Access Compliance Report

Public Rights-of-Way

Intersection ID: 4198	Main Street: CHASTAIN_PARC_DR	Cross Street: MT_HOLLY-HUNTERSVILLE_RD	Location: E
ADA ID: D0D901AD4D28	Ramp Type: Perp	Initial Pass/Fail: Fail	Overall Compliance: No
		Severity Score: 25

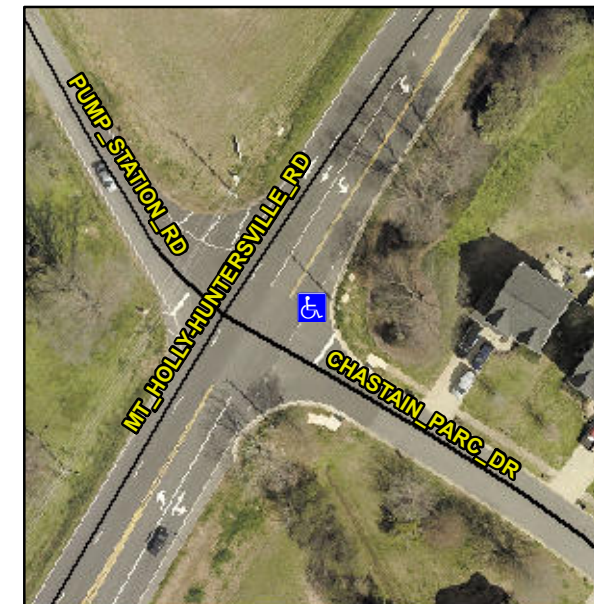
Not Found, R304.2.2, R304.5.3

Compliance	Description	Data	Compliance	Description	Data
N/A	Ramp Length (in)	49.0	No	Ramp Slope (%)	10.5
Yes	Ramp Width (in)	80.0	No	Ramp XSlope (%)	5.1
N/A	Flare Type LT	N/A	N/A	Flare Type RT	N/A
N/A	Flare Slope LT (%)	N/A	N/A	Flare Slope RT (%)	N/A
N/A	Flare Traversable LT?	N/A	N/A	Flare Traversable RT?	N/A
N/A	Landing Length (in)	N/A	N/A	DWS Provided?	N/A
N/A	Landing Width (in)	N/A	N/A	DWS Contrast?	N/A
N/A	Landing Slope (%)	N/A	N/A	DWS Length (in)	N/A
N/A	Landing X Slope (%)	N/A	N/A	DWS Full Width?	N/A
N/A	Landing Curb? (Y/N)	N/A	N/A	DWS Offset (in)	N/A
N/A	Shared Landing?	N/A			
N/A	Gutter Ponding?	N/A	N/A	Gutter Slope (%)	N/A
N/A	Gutter Lip Ht (in)	N/A	N/A	Gutter X Slope (%)	N/A
N/A	Painted X Walk1?	No	N/A	Painted X Walk2?	N/A
	X Walk 1 Direction	To W		X Walk 2 Direction	N/A
N/A	X Walk 1 Width (in)	N/A	N/A	X Walk 2 Width (in)	N/A
	X Walk 1 Slope (%)	4.0		X Walk 2 Slope (%)	N/A
	X Walk 1 X Slope (%)	4.4		X Walk 2 X Slope (%)	N/A

Remove & Replace Entire Ramp.
